UNITED STATES PATENT AND TRADEMARK OFFICE

APPLICATION NO.	FILING DATE	FIRST NAMED INVENTOR	ATTORNEY DOCKET NO.	CONFIRMATION NO.
10/714,670	11/18/2003	Sungkwon C. Hong	M4065.0982/P982	2308
24998	7590	10/24/2005	EXAMINER	
DICKSTEIN SHAPIRO MORIN & OSHINSKY LLP			NGUYEN, THINH T	
2101 L Street, NW			ART UNIT	PAPER NUMBER
Washington, DC 20037			2818

Office Action Summary

FIG. 1

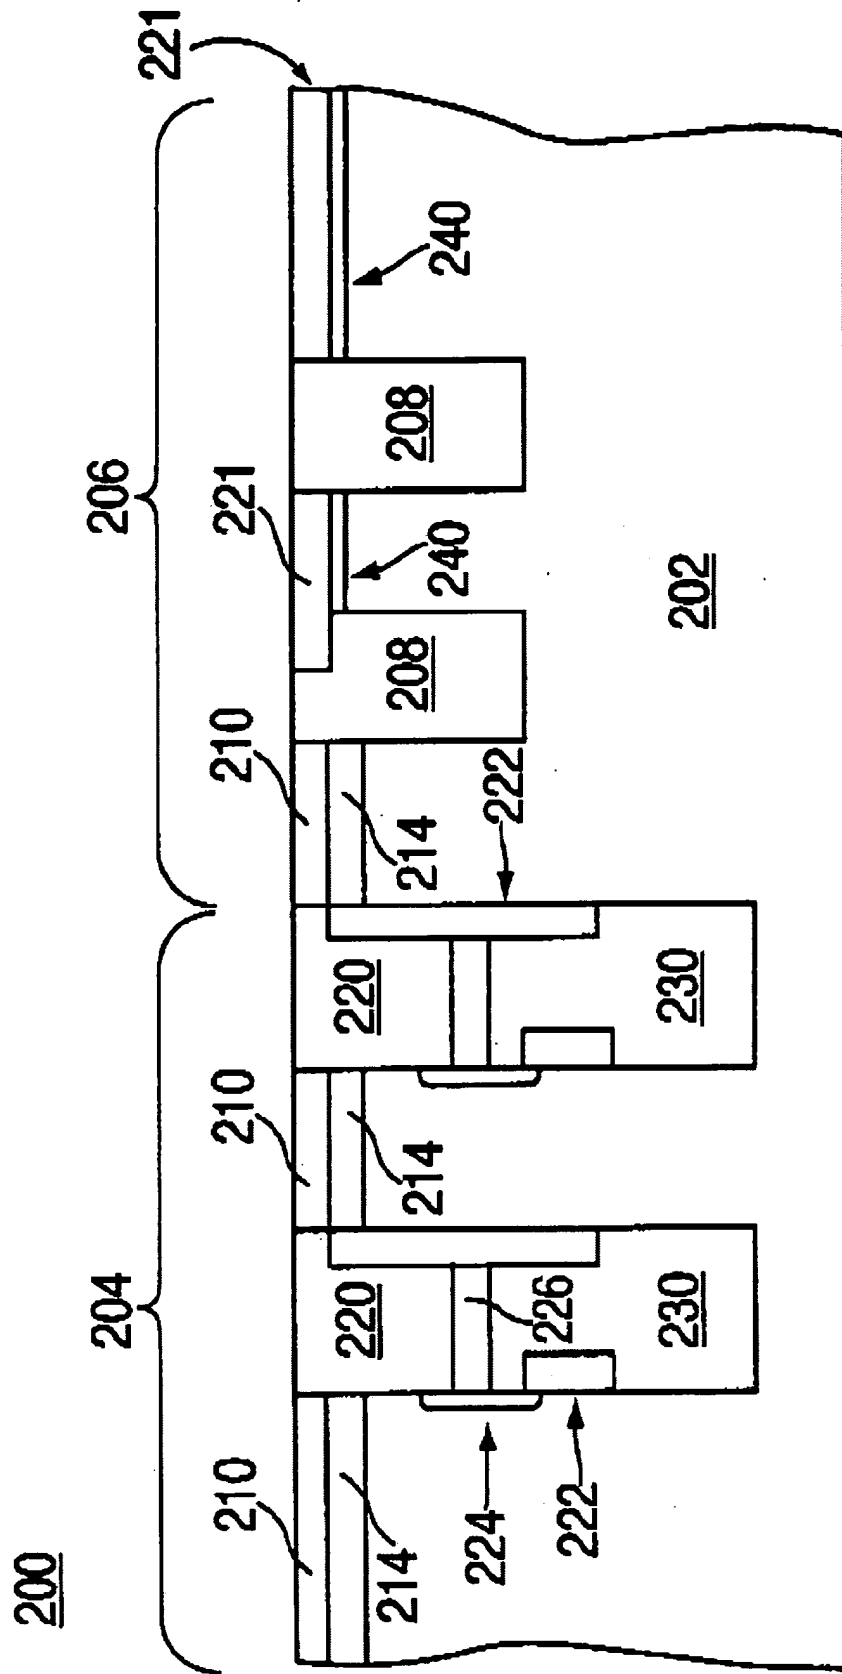
Divakaruni discloses (the abstract, fig 1,fig 2, fig 3, fig 4) a method of forming a memory cell, comprising the steps of: forming a transistor including a gate fabricated on a semiconductor substrate and including a source/drain region in the semiconductor substrate disposed adjacent to the gate, the step of forming the transistor including providing a silicide region (fig 4 region 252,column 8 lines 48-50) of the gate; and forming a capacitor adjacent the transistor by providing a first conductive layer (fig 4 layer 230), a dielectric layer (fig 4 layer

Divakaruni discloses (the abstract, fig 1,fig 2, fig 3, fig 4) all the invention except for going into detail about fabricating the second conducting layer capacitor plate from undoped polysilicon.. This feature, however, is considered obvious since the use of undoped polysilicon as capacitor plate is old and well known in the art as evidenced by the disclosure by Sandhu et al. (US patent 6,124,607) column 4 lines 18-21 or Reinberg et al. (US patent 5,142,438) column 2 lines12-15.

FIG. 4

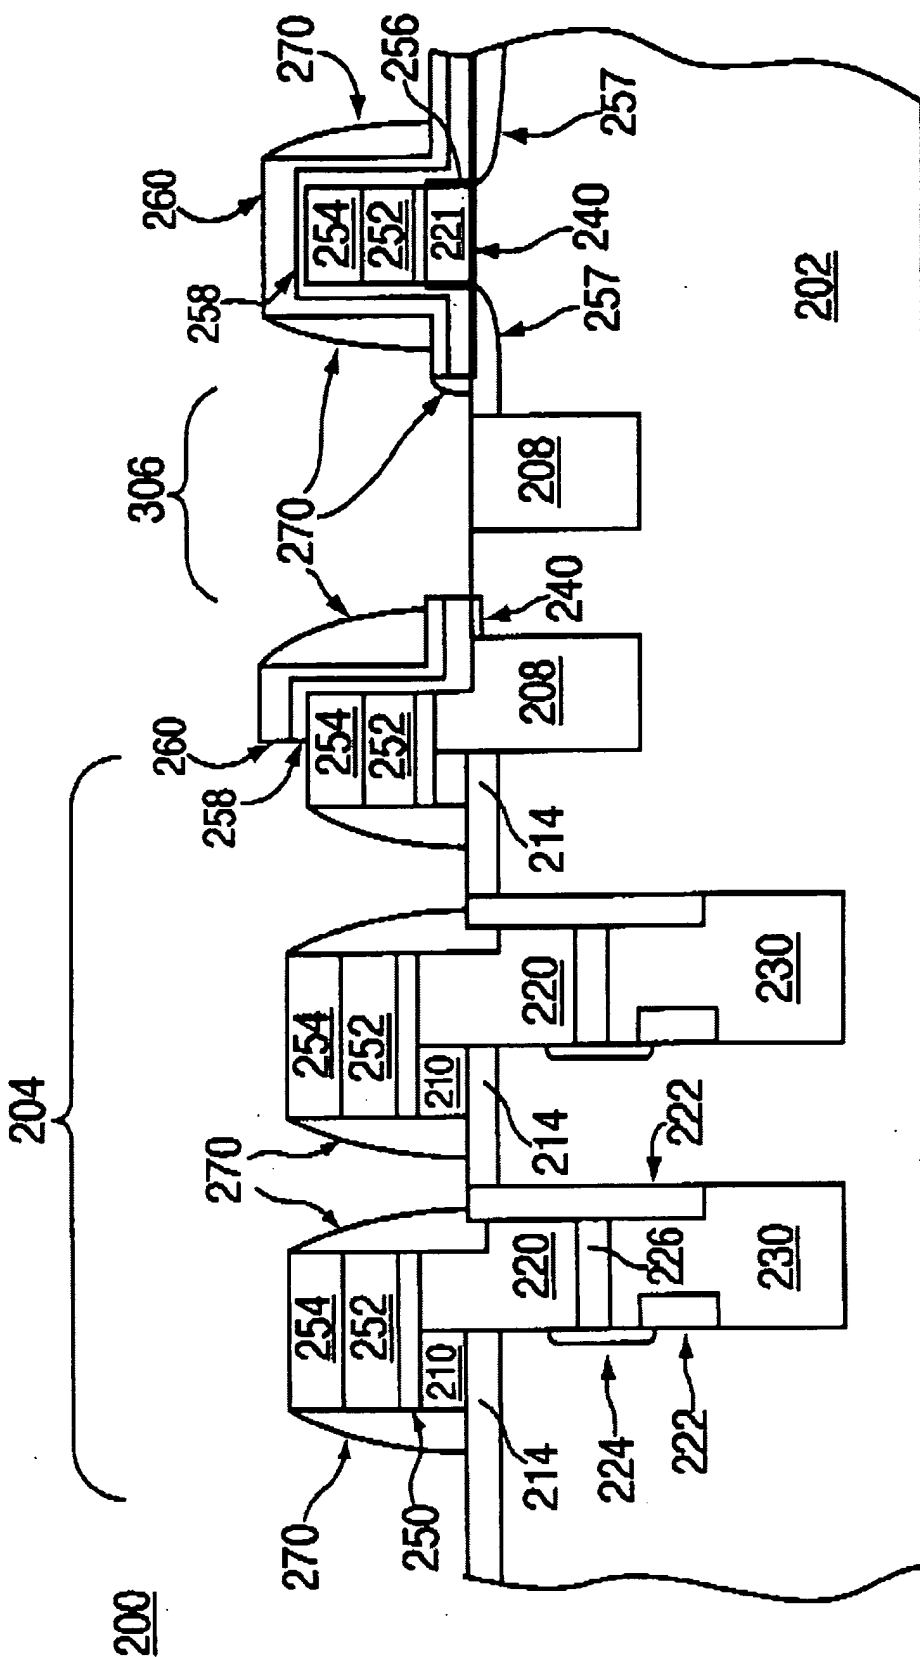
226) and a second conductive layer, (fig 4 layer 220) wherein the steps of providing the first conductive layer, the dielectric layer and the second conductive layer are conducted prior to the step of providing the silicide region of the gate.

Divakaruni discloses (the abstract, fig 4 layer 230, column 2 lines 5-10, column 7 line 41) a method for fabricating DRAM wherein the first conductive layer of the capacitor is formed of doped polysilicon layer

Divakaruni discloses (the abstract, fig 4) a method for fabricating a DRAM device that uses MOSFET transistor.
